Groundwater Transfer Review Summary Form

Transfer/PA # T- 14433

Application: T-14433

Applicant Name: Twin Springs LLC, c/o Lili Tova

Modeled Interference: Authorized Well 1 to CLAC 51283

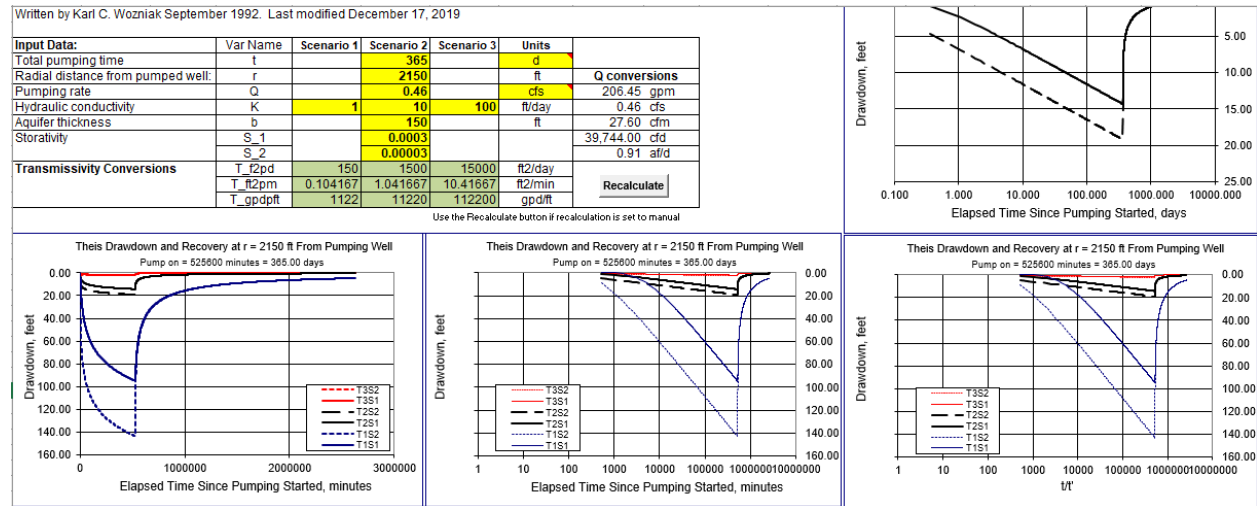
4. ☐ Yes ☒ No If yes, explain: The potential interference between Well 5 and CLAC 51283 was evaluated with the maximum authorized rate of 0.46 cfs (~206 gpm). The results are shown on the attached figures. The relatively minor change in distance does not substantially change the modeled drawdown. Under more conservative aquifer parameters, drawdown may temporarily exceed 25 feet, particularly during irrigation season pumping; however, under all aquifer parameter scenarios evaluated, the total drawdown equilibrates to less than 25 feet. Therefore, the proposed change is unlikely to result in another groundwater right not receiving the water to which it is legally entitled.
